UNITED STATES PATENT AND TRADEMARK OFFICE

APPLICATION NO.	FILING DATE	FIRST NAMED INVENTOR	ATTORNEY DOCKET NO.	CONFIRMATION NO.
10/816,585	03/31/2004	William H. Whitted	GOOGP022	8421

Office Action Summary

DETAILED ACTION

Fig 1

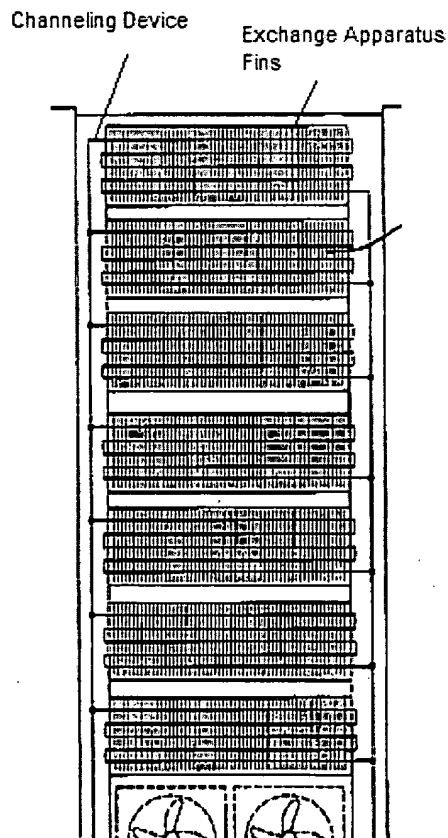
With respect to claim 8, Chu et al. further teaches that each heat exchanger includes a heat exchange fluid channeling device and a heat exchange apparatus in thermal communication with the heat exchange fluid channeling device (See present office action Fig 1 below).

With respect to claim 19, Chu 770 further teaches that the means for cooling air (21) includes a means (As illustrated in the present office action Fig 1 above) for channeling a heat exchange fluid and means (Fins as illustrated in POA Fig 1 above) for channeling the heat exchange fluid extends.

With respect to claim 20, Chu 770 further teaches that the means for heat exchange includes a plurality of heat exchange fins through which the means for channeling the heat exchange fluid extends (As illustrated in POA Fig 1 above).
